City of Ketchum

Recommendation To Approve Change Order #5 to Contract 20454

Project Description: Fire Station CM/GC

Change Order #:005

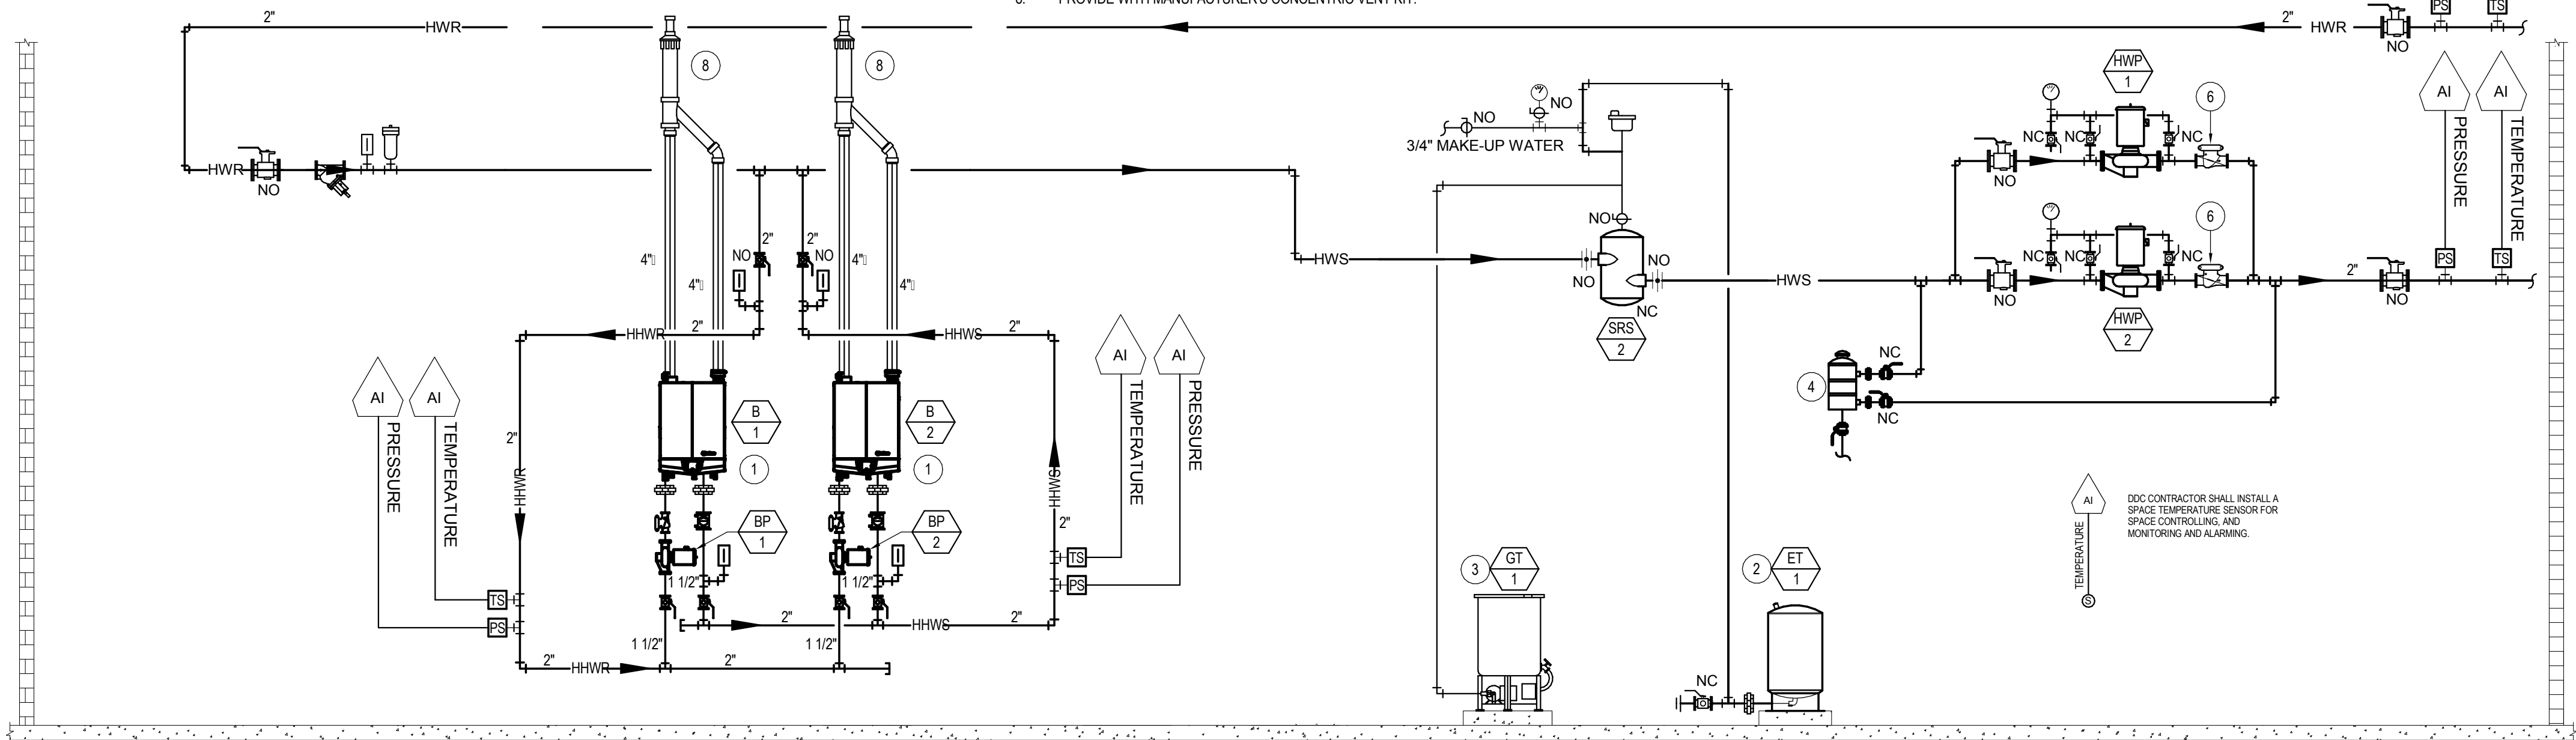
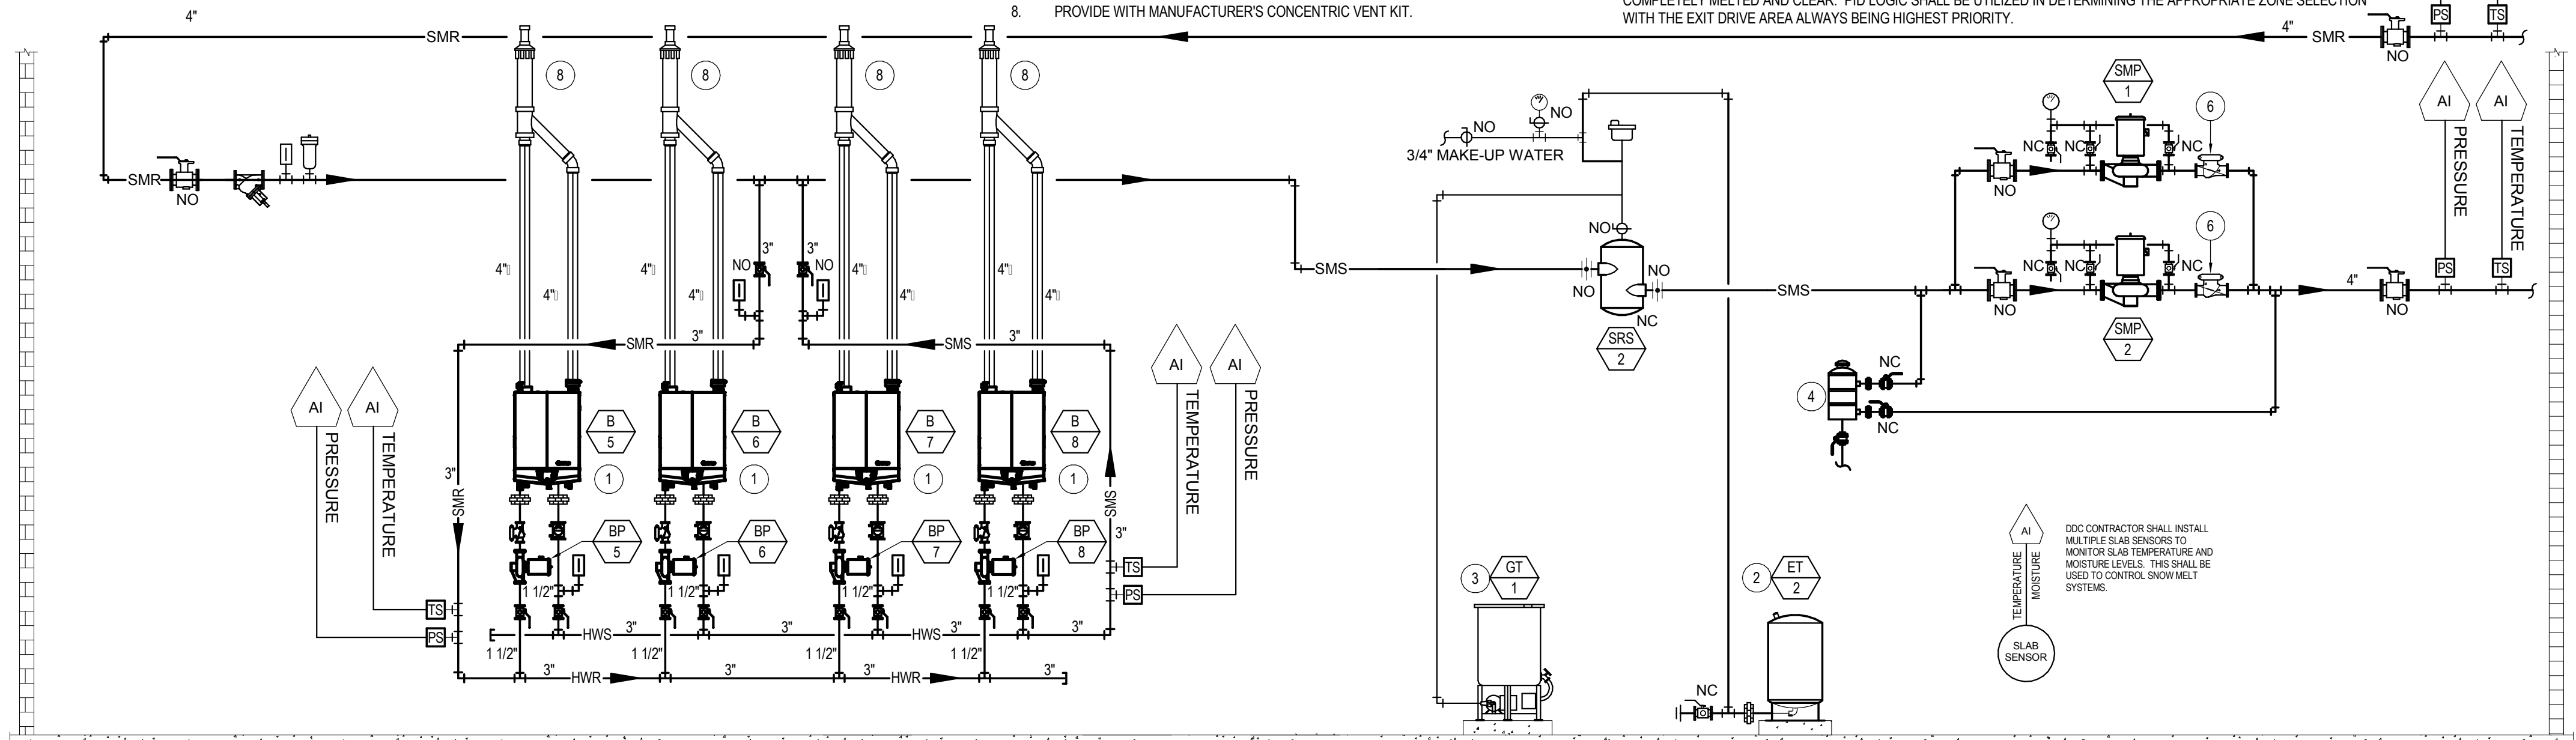
In the Apparatus Bay the Supply Fan SF-1 was changed to a Penthouse Fan PH-1 in ASI #2, however the Hot Water Coil HWC-1 was not deleted. Please confirm the HSC-1 is not required with the PH-1 and if it can be deleted does the hot water demand go down enough to delete a boiler (one of Boiler1-4) from the mechanical room?

Per RFI 144, reduce the number of wetside mechanical boilers from 8 to 6, and reduce the main pipe size from 4" to 2".

Yes, HWC-1 can be removed as part of ASI#2. While reviewing the Radiant Floor system it was discovered that HWC-1 made up a majority of the heating and flow requirements in that system. Now that HWC-1 is gone we have reduced the number of boilers used, downsized the supply pumps and reduced pipe size. We have omitted boilers 3 and 4 from the project (along with pumps BP-3 and BP-4) and we have reselected HWP-1 and HWP-2 to provide 30 gpm at 55' of head along with reducing the main pipe sizing from a 4"Ø to a 2"Ø. Please see the updated sheets attached with changes to the Radiant Floor Hot Water Piping Schematic, updated Boiler and Pump schedules along with the removal of the schedule for the removed hot water coil.

M1.00

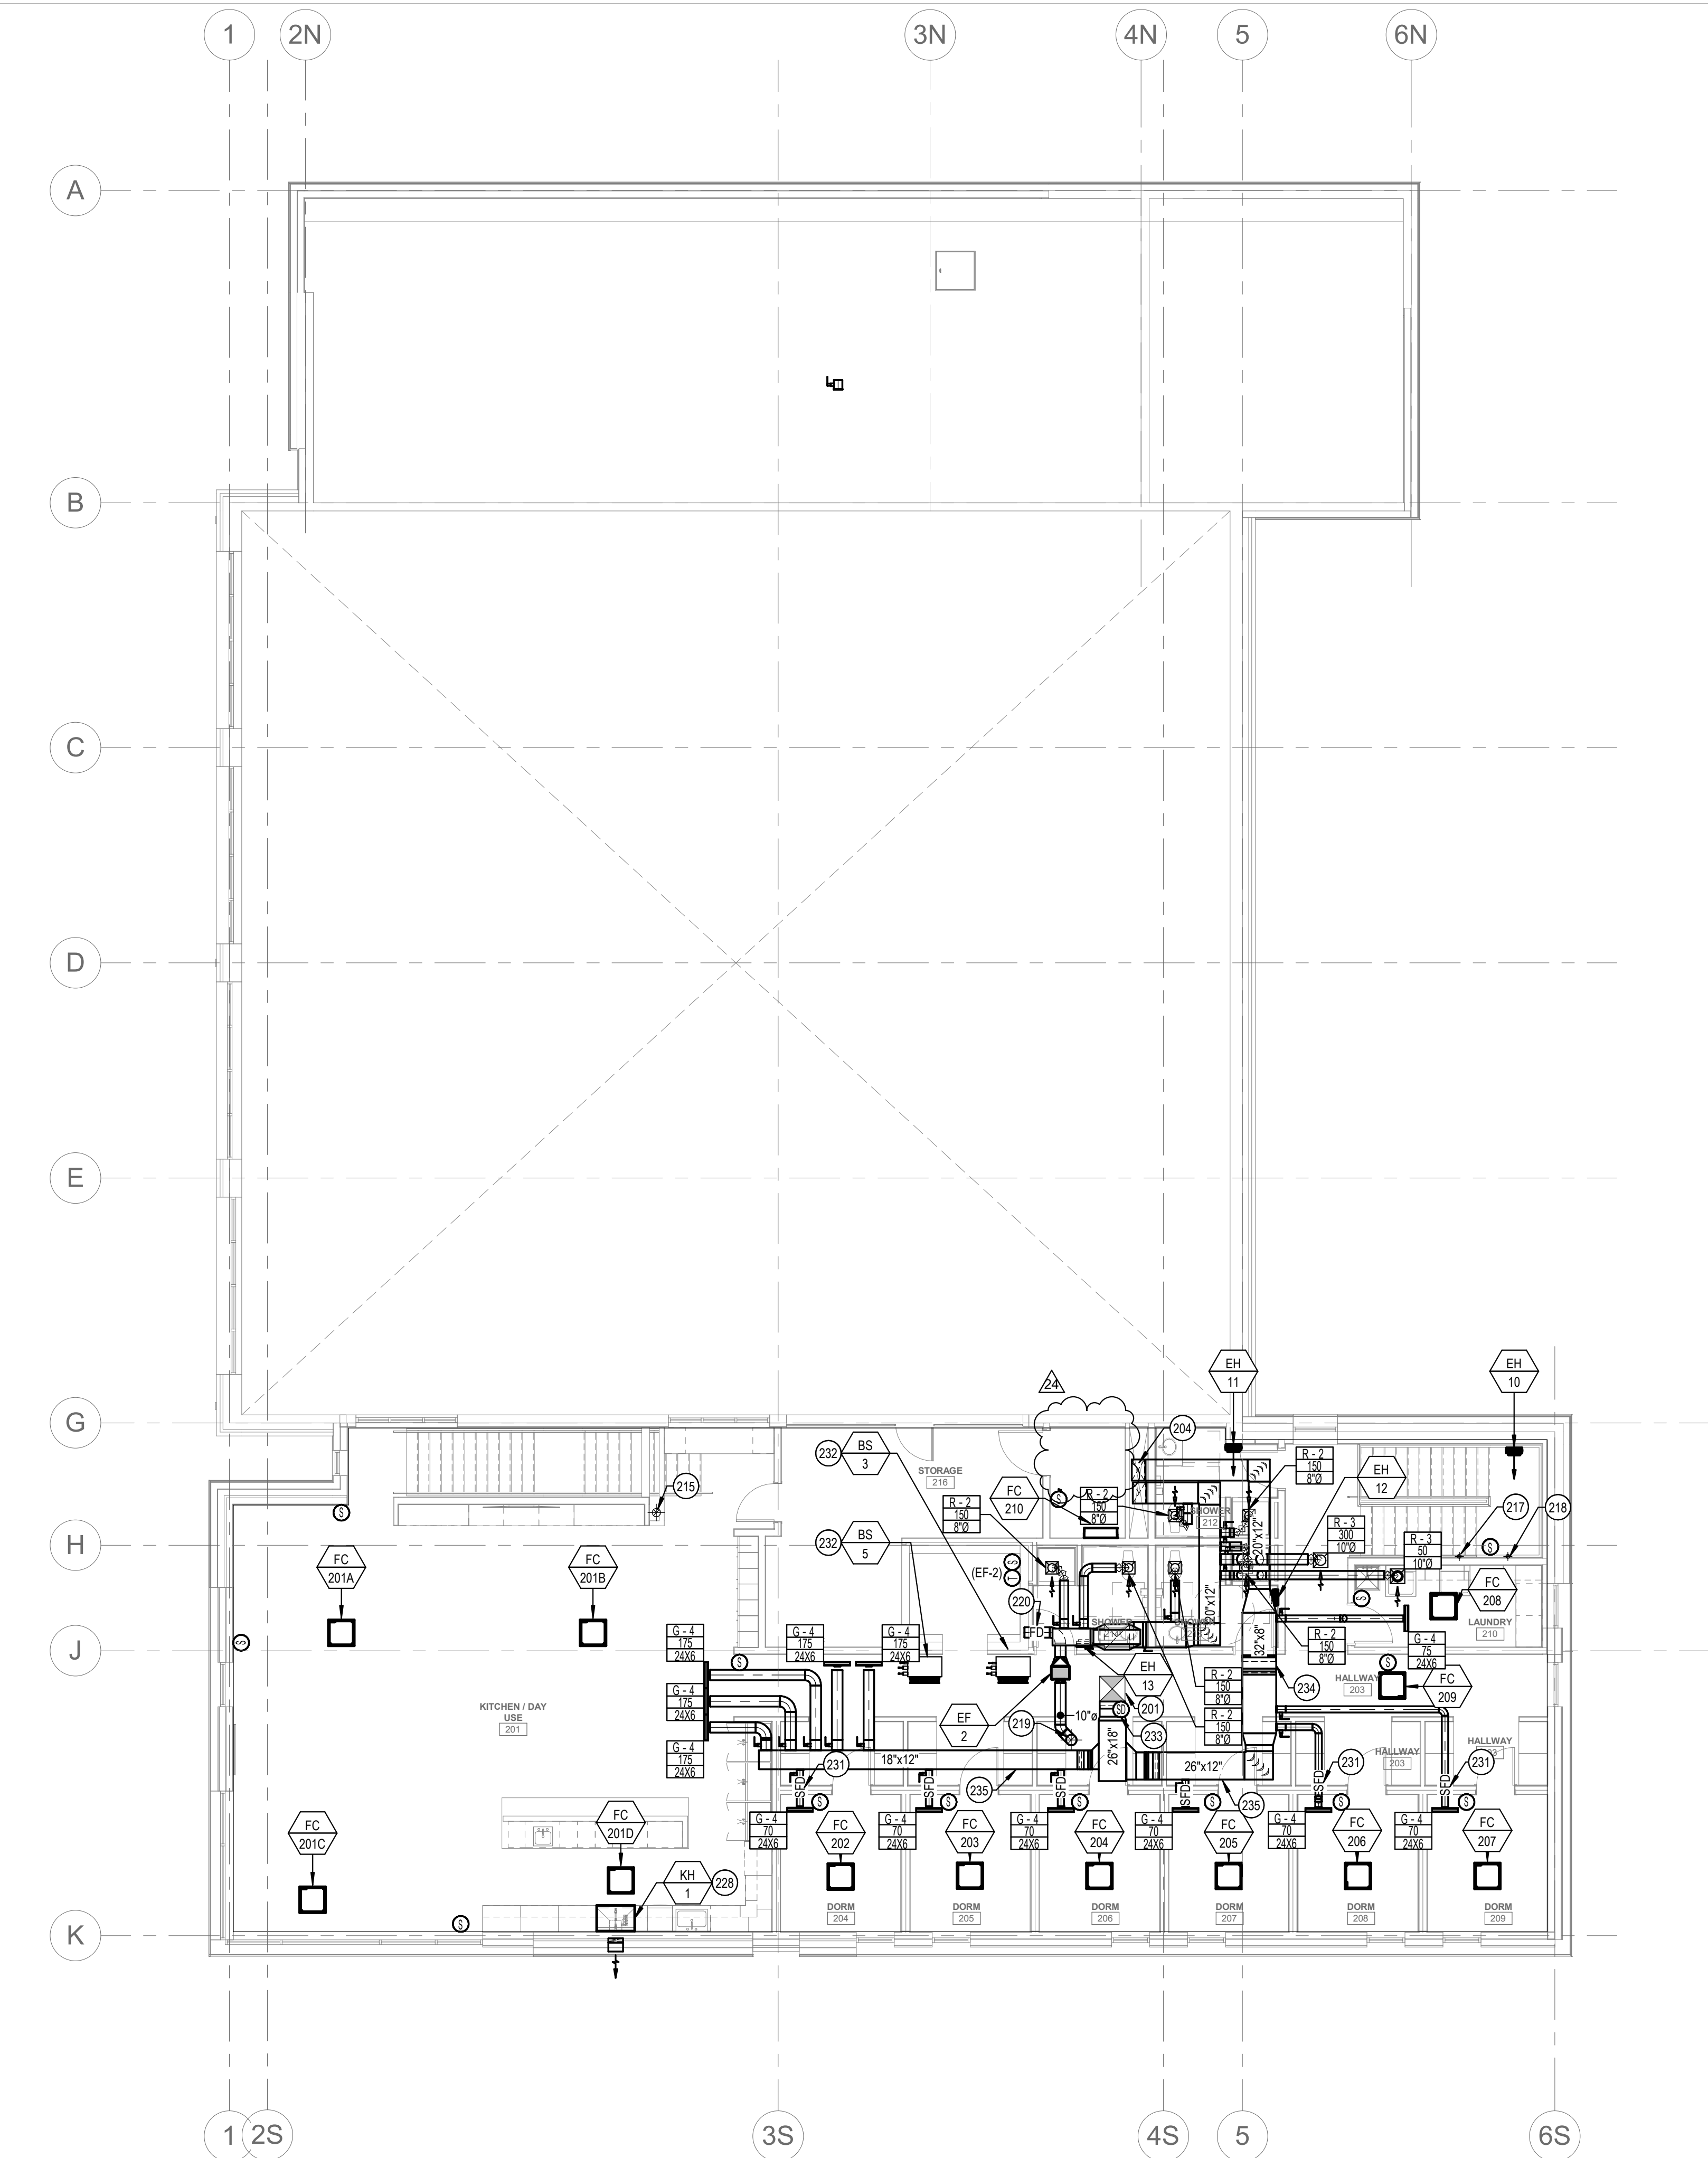
The owner is opting to remove the redundancy of fan coil units in the IT rooms. Please confirm the equipment that is to be removed from the scope of the project so that a credit can be provided. IT 109 has FC 112 fed from the VRF and DFC/DCU 1. IT Room 217 has FC 210 fed from the VRF and DFC/DCU 2.

1. M1.00 – HVAC PLAN- LEVEL 01
 - a. Removed DFC-1 and associated thermostat.
2. M1.01 – HVAC PLAN- LEVEL 02
 - a. Removed DFC-2 and associated thermostat.
3. M1.04 – HVAC ROOF PLAN
 - a. Removed DCU-1 and DCU-2.
 - b. Removed keyed note 230.
4. M4.00– HVAC SCHEDULES
 - a. Removed Ductless Split System Air Conditioning Unit Schedule.
